Product Change Notification

PCN-AI-7531-2021

Business Unit	Product Line Code	Type of Change	Action	Date of Issue
AI - Automation Infrastructure	DNA	Product Change Notification	Notify Distributors and Field	12/21/2021

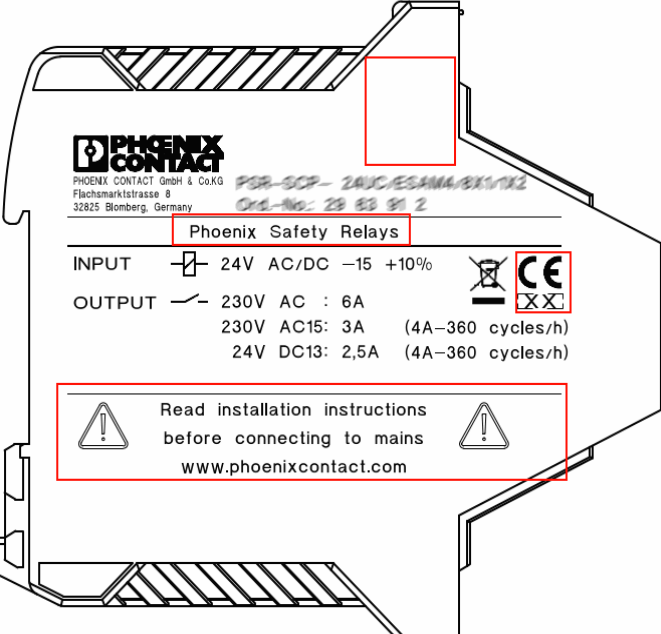
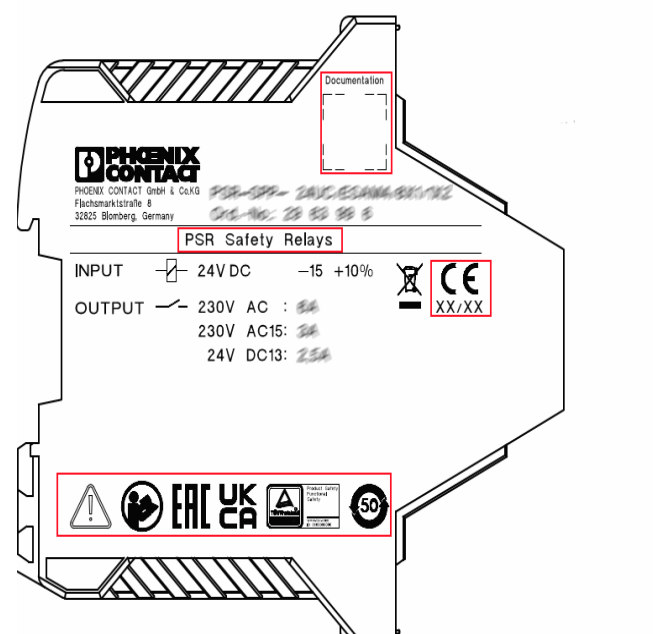
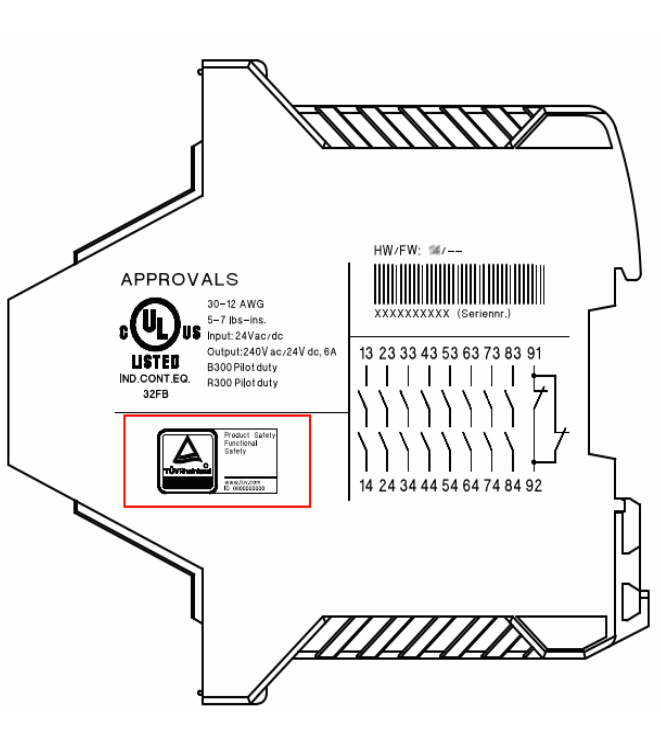
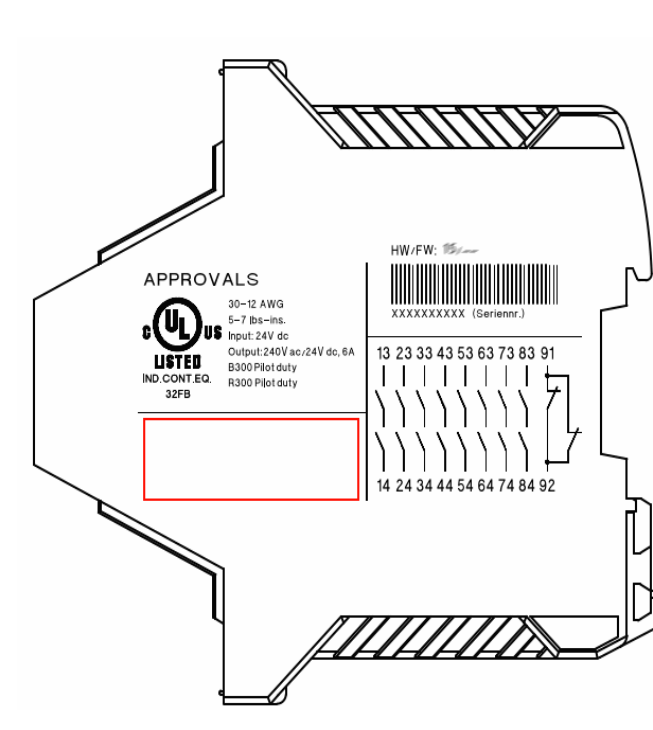
Due to the hardware change, the listed items can no longer be operated via an AC supply voltage, and are therefore only compatible with old item versions to a limited extent. The modified technical values are listed in the attachment. In addition, non-coded plugs will be installed, the packing slip will be changed over to a new documentation concept, and a smaller folding carton will be used.

In addition to the year of manufacture, the calendar week will also be displayed below the CE mark. The various pictograms and TÜV approvals will be displayed in the lower area on the left half of the housing; the plug will no longer be coded.
